BEFORE THE
UNITED STATES NUCLEAR REGULATORY COMMISSION

Application for Amendment to
Appendix A of Facility Operating License
License No. DPR-34

OF THE
PUBLIC SERVICE COMPANY OF COLORADO
FOR THE
FORT ST. VRAIN NUCLEAR GENERATING STATION

FIGURE 3.3-1

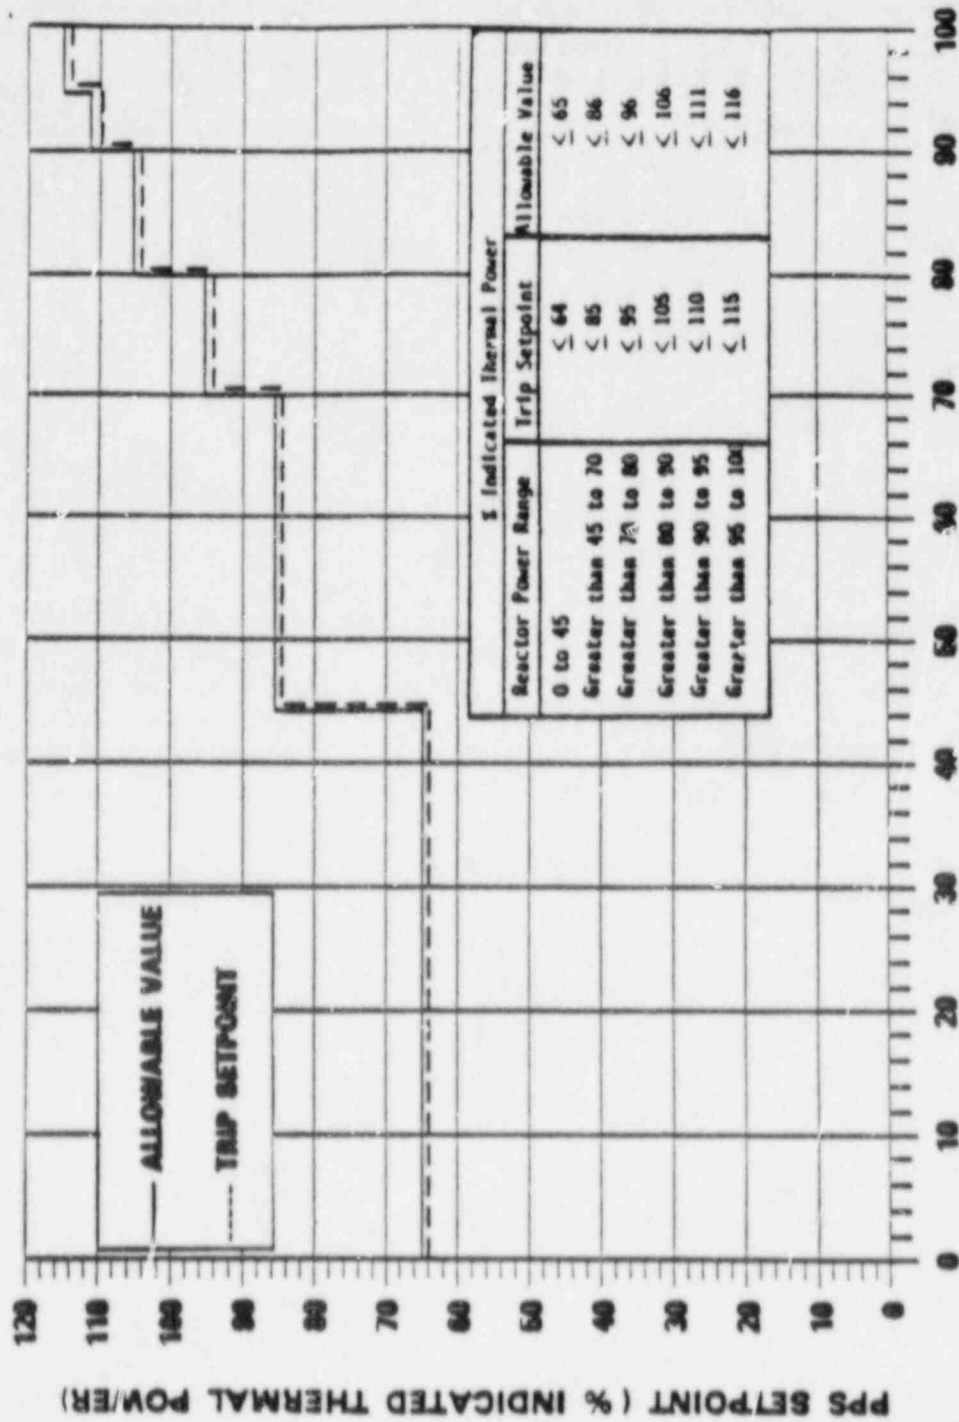
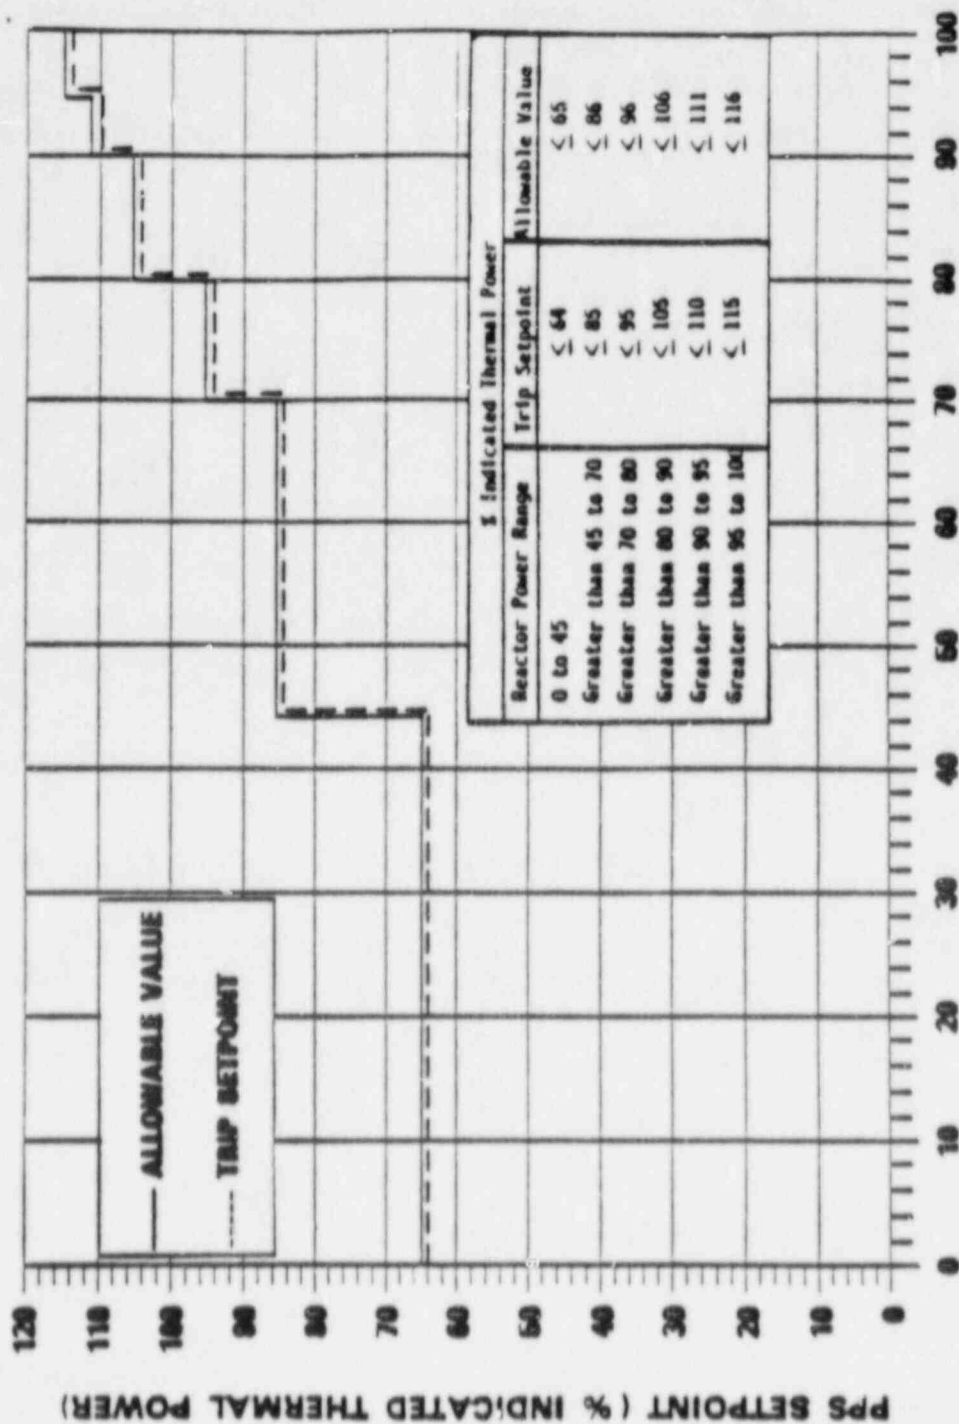
HIGH NEUTRON FLUX SCRAM
 DETECTOR DECALIBRATION
 CURVES FOR CYCLE 4
